Service Bulletin

Bulletin No.: P11032

Subject: Click Noise Heard from Front Compartment Area, Possible DTC P059F Set

Models: 2014 Chevrolet Spark EV
Condition/Concern

3596935

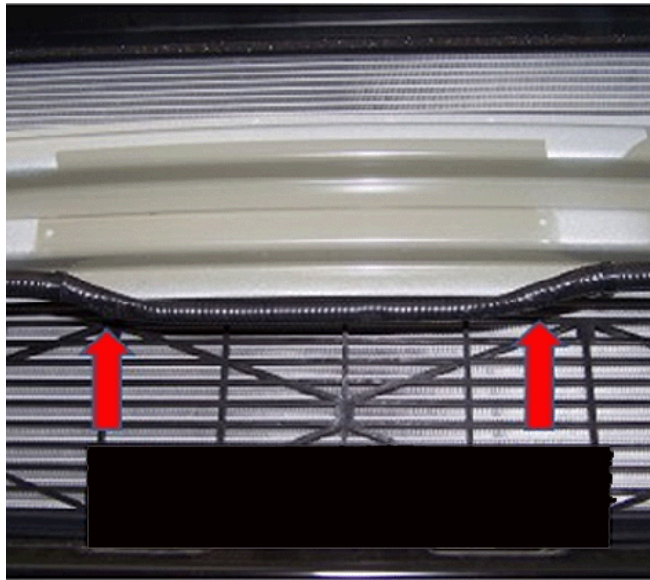
Reposition the wiring harness by taping up the harness as shown below. Once the front fascia assembly is installed, the harness will be supported by the shutter housing.

This condition may be caused by the harness dropping down during installation of the front fascia and causing the air shutter housing to be pushed down and contact the louvers when opening or closing.

3596939

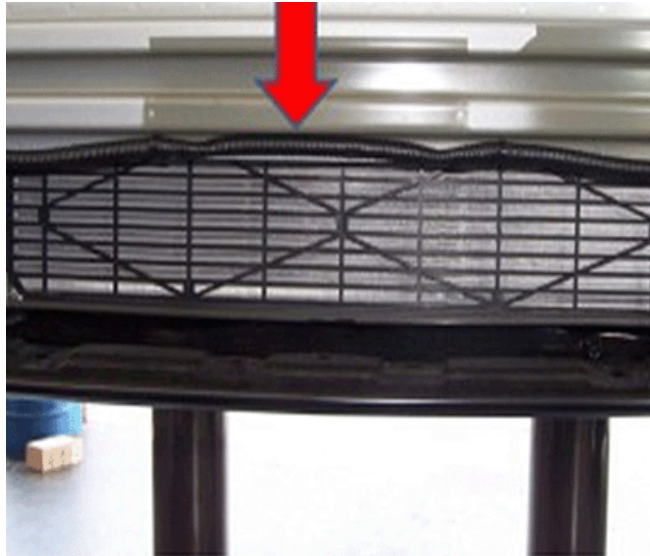
The above graphic shows the pinched portion of the harness where it has dropped down and pushed on top of the louver housing causing contact.

3596936

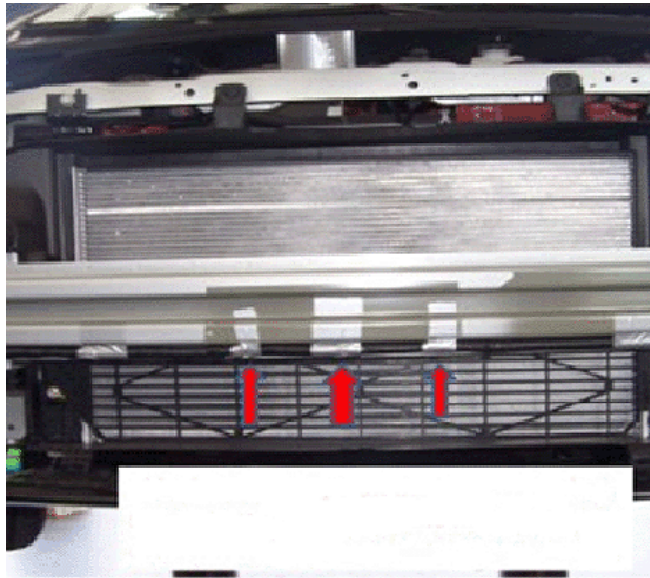
The above graphic shows where the harness should be positioned to not contact the air shutter louvers.
